City of Arts & Innovation

CERTIFICATE OF APPROPRIATENESS

CULTURAL HERITAGE BOARD MEETING DATE: September 18, 2013

I. CASE NUMBER(S): P13-0465

P13-0465, Exhibit 3 - Proposed Site Plan

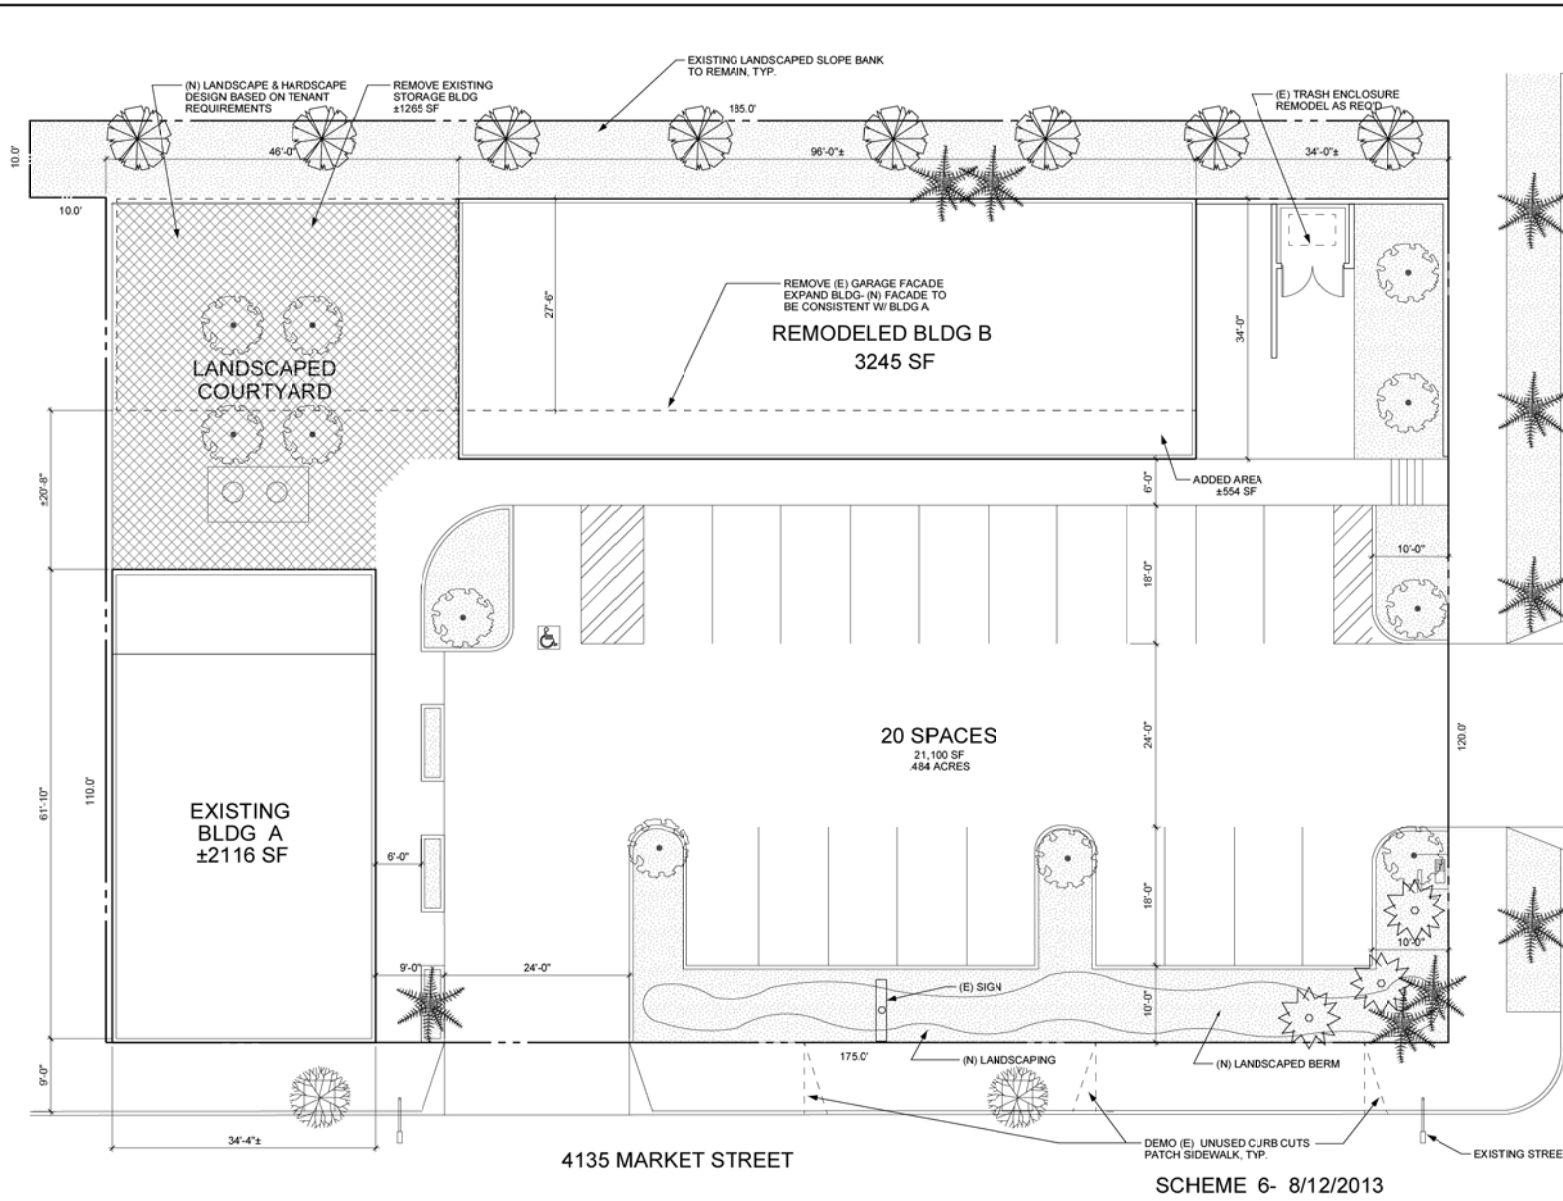
6. **Staff Required Plot Plan Conditions:** Revise the submitted plot plan such that the plan provided for building permit plan check incorporates the following changes:

- a. The trash enclosure shall meet the Zoning Code and Citywide Design Standards.
- b. The front of the enclosure shall be enclosed with an appropriate material and latched gate, painted to match.
- c. A cover shall be designed over the trash enclosure subject to Planning and Citywide Design Standards.
- d. *Advisory:* Consult with the Building & Safety Division for all ADA Standards and Regulations relating to trash enclosures, and generally for the site.
- e. The plot plan shall be revised to eliminate stairs in the walkway leading into the site from the Eleventh Street sidewalk.
- f. Wheel stops shall be used for parking spaces that are directly next to a building, walkway or those parking spaces that are near light standards as required by the Building Code.

- d. The berm and plants/shrubs used along the southerly property line shall be tall enough to screen the adjacent parked vehicles from Market Street.

P13-0465, Exhibit 3 - Proposed Elevations

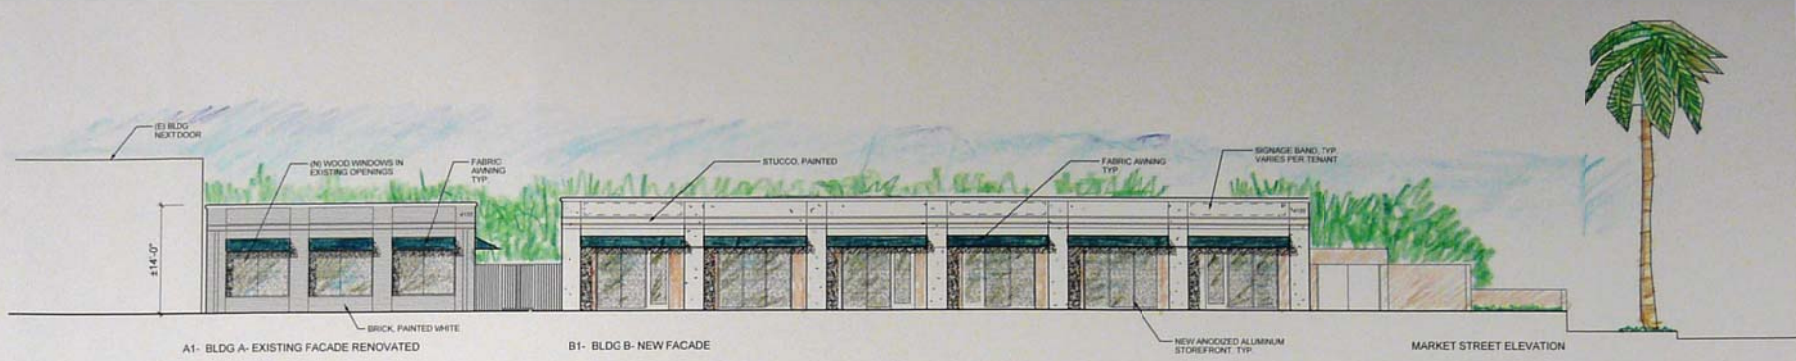
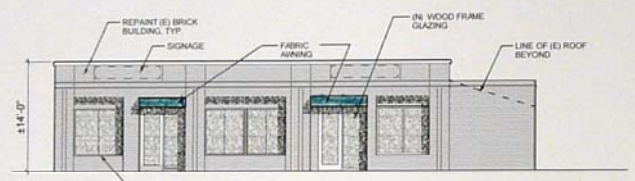
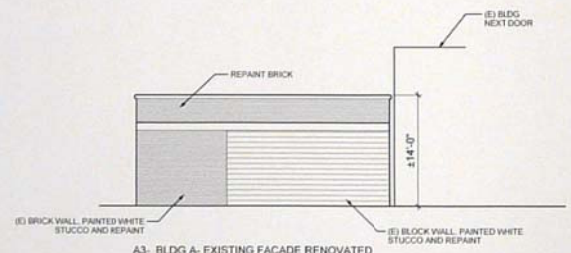
5. **Staff Required Building Elevations Conditions:** Revise the building elevations such that the plans provided for building permit plan check incorporate the following changes:

- b. Original windows on the historic building shall be repaired if possible, or replaced like-for-like if too deteriorated. Replacement windows and new storefront systems shall be wood and match the style, arrangement of panes and profile of the original windows subject to the approval of the CHB staff.

- c. For areas of the historic building where proposed storefronts are smaller than existing openings (i.e., service bay door), the openings shall be filled in with brick masonry that

matches the dimensions and coursing of the existing brick building but slightly recessed so as to allow the original opening size to be distinguished.

- e. Include details of mechanical equipment and/or screening as follows:
 - i. For the existing historic building, unless the existing and/or addition parapet is of a height equal to or higher than the height of the mechanical equipment, locate associated mechanical equipment on the ground behind the building. In the extreme event that roof-mounting of equipment is the only alternative, then prior to issuance of permits, submit a detailed plan and sight line study that locates equipment in a compact arrangement in the least visible rear corner of the roof; screening material options and samples shall be submitted to CHB staff and may necessitate installation of mock-ups in the field prior to approval.

- iv. For the existing historic building, submit plans that clearly show a location for any required exhaust hood venting or similar equipment associated with a restaurant use that does not penetrate masonry and as inconspicuous as possible to the satisfaction of CHB and Building and Safety staff.
